Browns Ferry Nuclear Plant, Unit 1
Facility Operating License No. DPR-33
NRC Docket No. 50-259

Subject: **Response to NRC Request for Additional Information Regarding a Request to Transition to AREVA Fuel (TAC No. ME3775)**

Technical Specification Change TS-473 - AREVA Fuel Transition

TVA Response to Request for Additional Information
(Non-Proprietary)

Figure 2 Limiting TLO Recirculation Line Break
Upper Plenum Liquid Mass (300 to 650 Seconds)

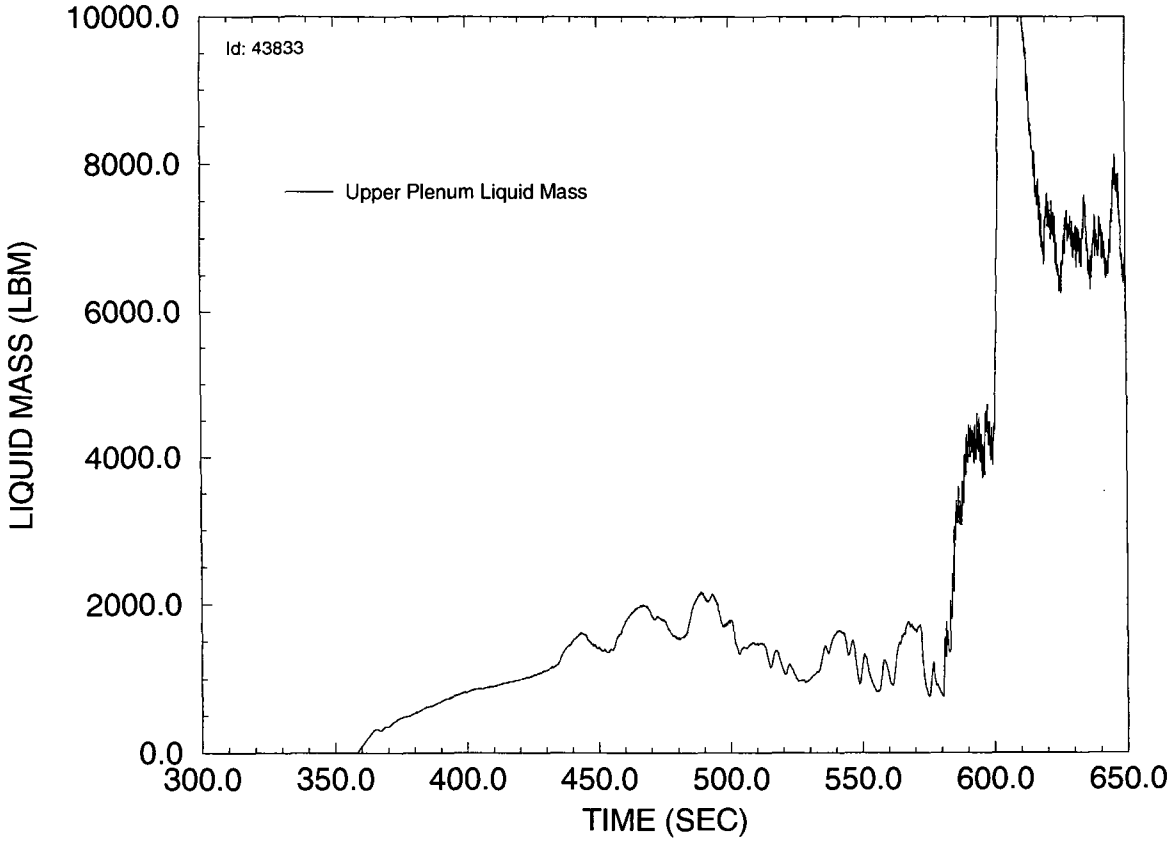
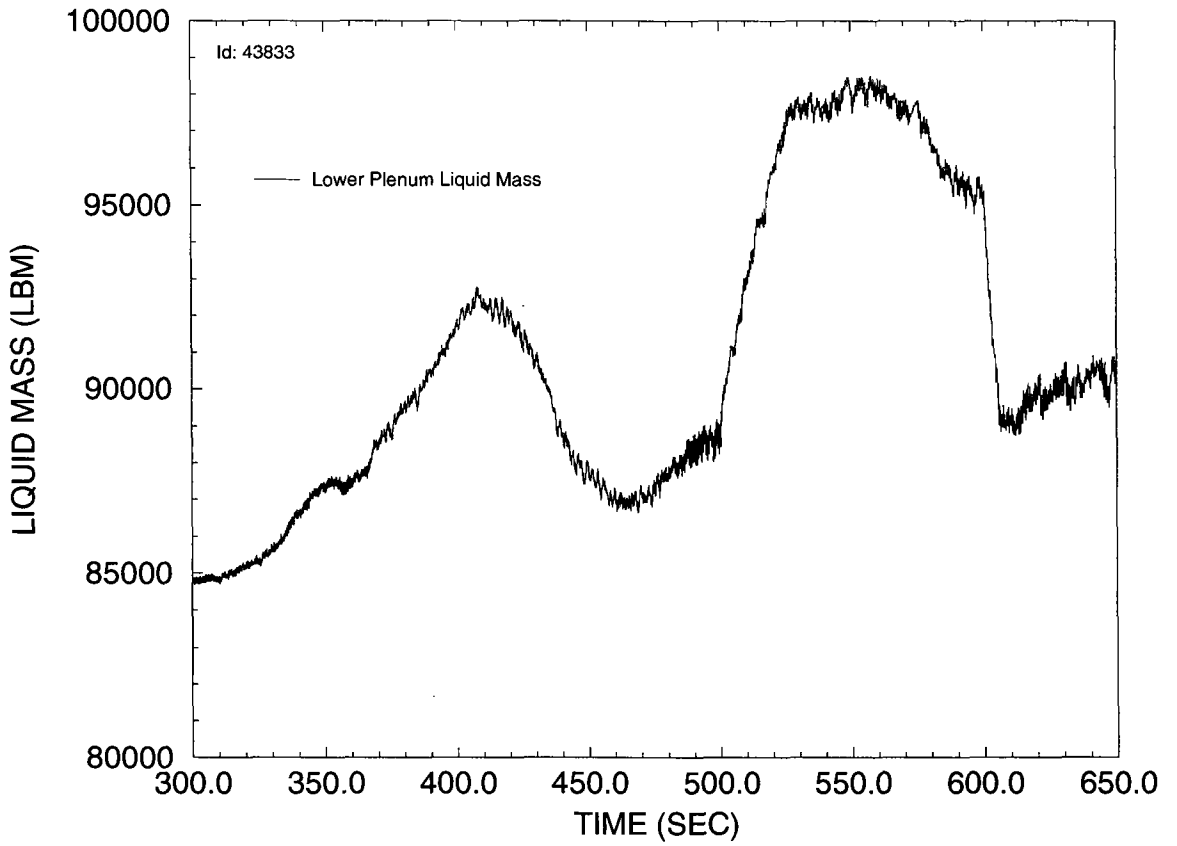
NRC Question 5

Provide a plot of upper plenum liquid mass with higher resolution from 0-10000 lb from the period between 300 seconds and the end of the transient. Provide similar plots (i.e., increased resolution at the region of interest) of liquid mass for the core average, bypass, and hot channel regions and the lower plenum.

Attachment 2 - Figures 2 to 6 show upper plenum liquid mass, total core liquid mass, bypass region liquid mass, hot channel total liquid mass, and lower plenum liquid mass for the 300 to 650 second time interval of the limiting LOCA case. The y-axis on each plot has been adjusted to provide increased resolution.

Figure 7 Limiting TLO Recirculation Line Break Smoothed Hot Channel Inlet Flow (350 to 500 Seconds)

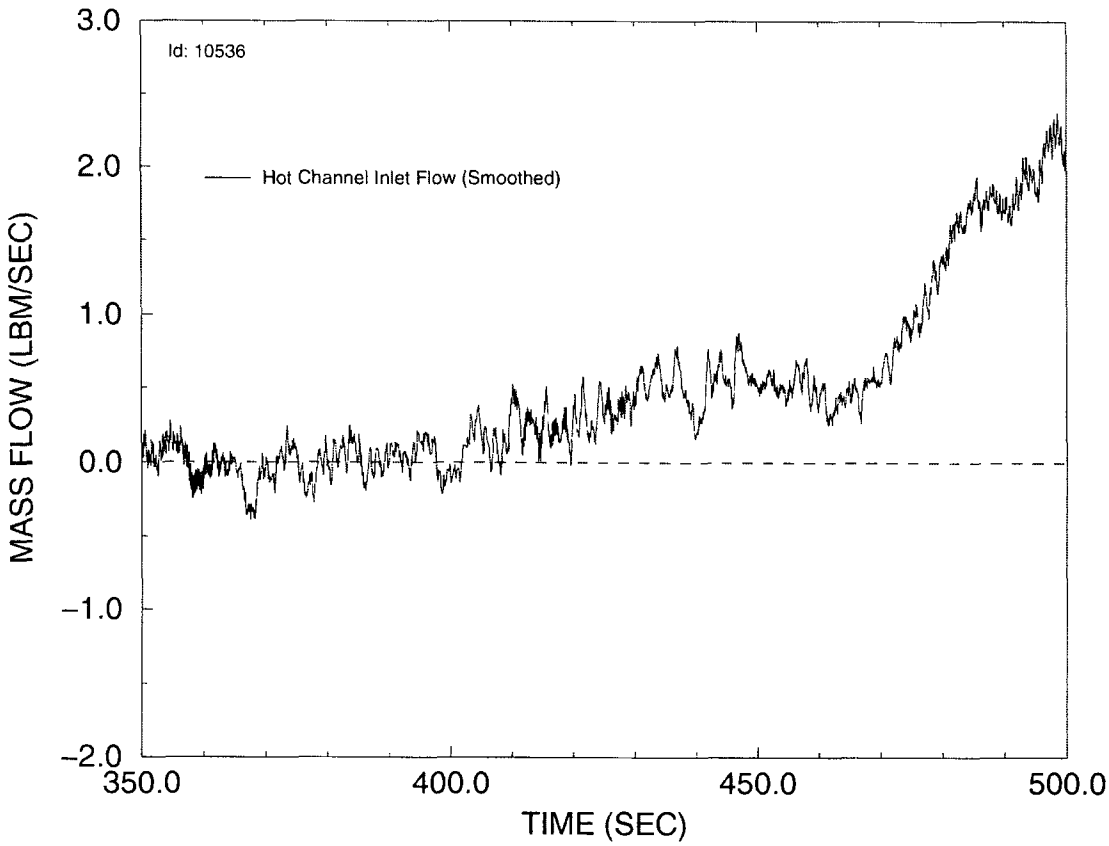
NRC Question 7

Provide a higher resolution plot of hot channel inlet flow rate from 350–500 seconds. Trace the zero line through the plot.

Attachment 3 - Figure 7 shows hot channel inlet flow for the 350 to 500 second time interval of the LOCA. **[**
